PLAN & PROFILE

SHEET 4 OF 11

LAKE COUNTY
SEWERAGE IMPROVEMENTS
GREATER MENTOR SEWER DISTRICT
IMPROVEMENT No. 92-S
CONTRACT - A

PLAN & PROFILE STA 0+00 TO STA 4+05

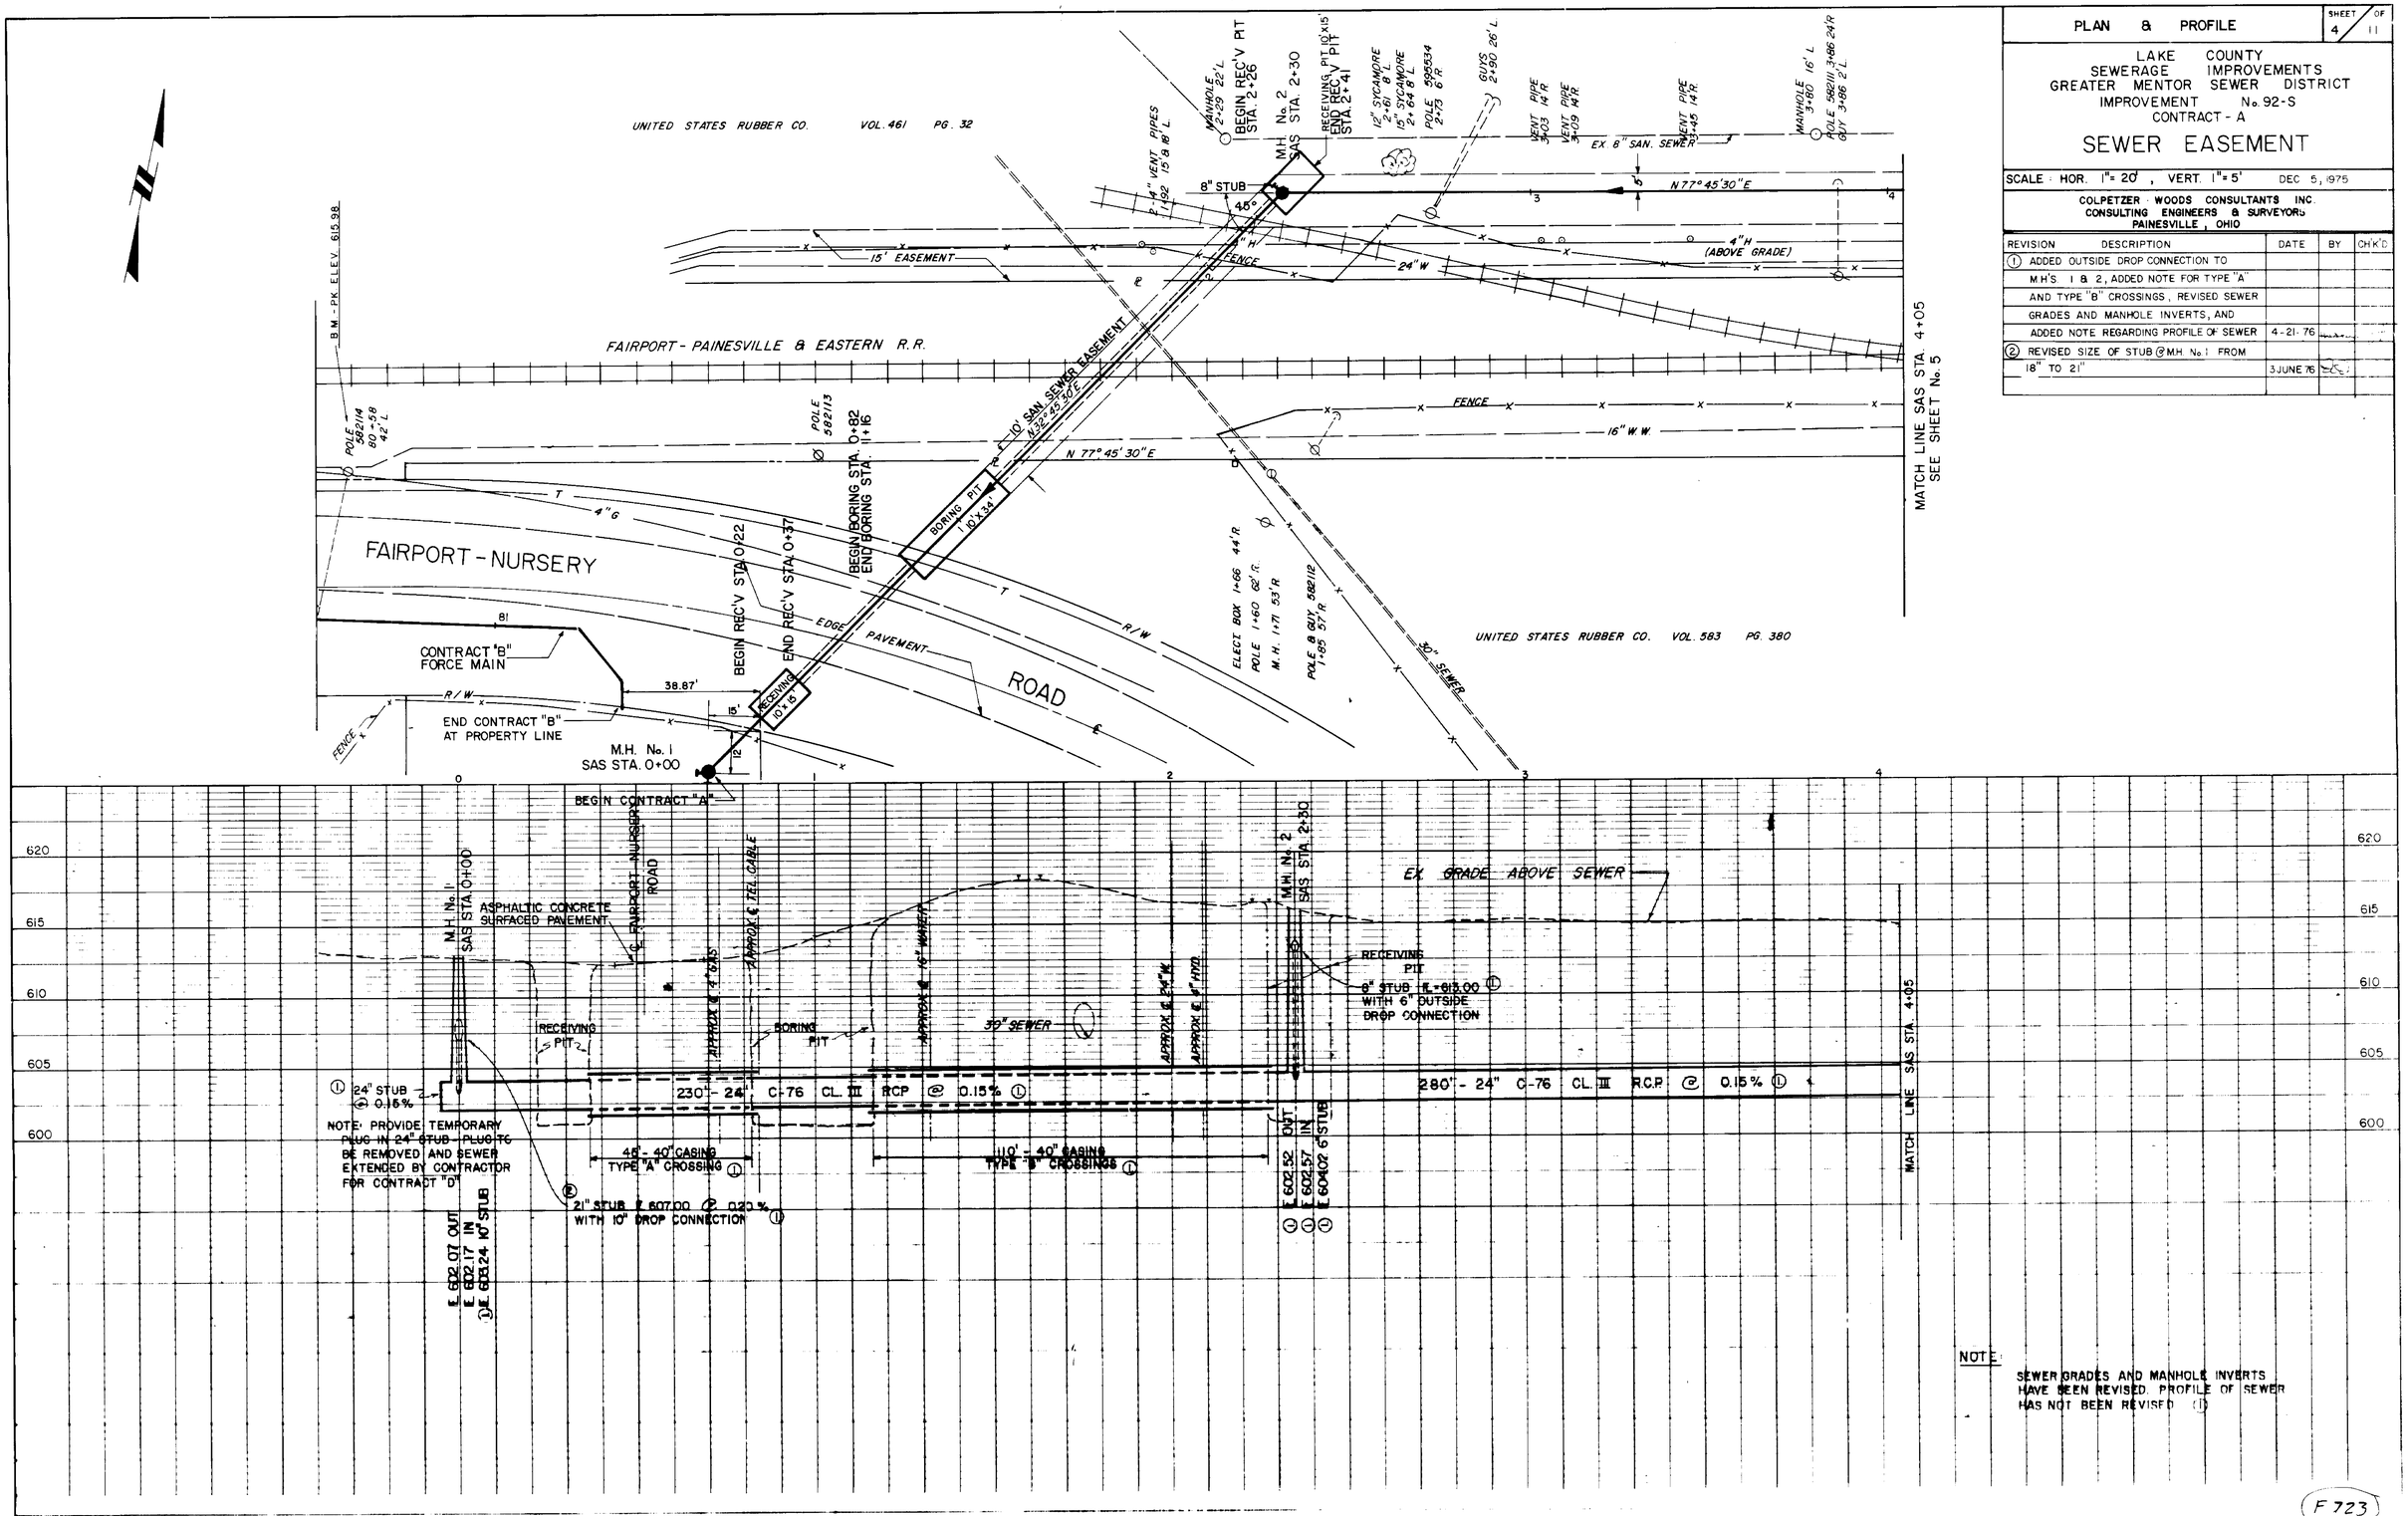
REVISION	DESCRIPTION	DATE	BY	CH'K'D
1	ADDED OUTSIDE DROP CONNECTION TO			
	M.H.'S 1 & 2, ADDED NOTE FOR TYPE "A"			
	AND TYPE "B" CROSSINGS, REVISED SEWER			
	GRADES AND MANHOLE INVERTS, AND			
	ADDED NOTE REGARDING PROFILE OF SEWER	4-21-76		
2	REVISED SIZE OF STUB @ M.H. No. 1 FROM			
	18" TO 21"	3 JUNE 76

NOTE:
SEWER GRADES AND MANHOLE INVERTS HAVE BEEN REVISED. PROFILE OF SEWER HAS NOT BEEN REVISED (1)
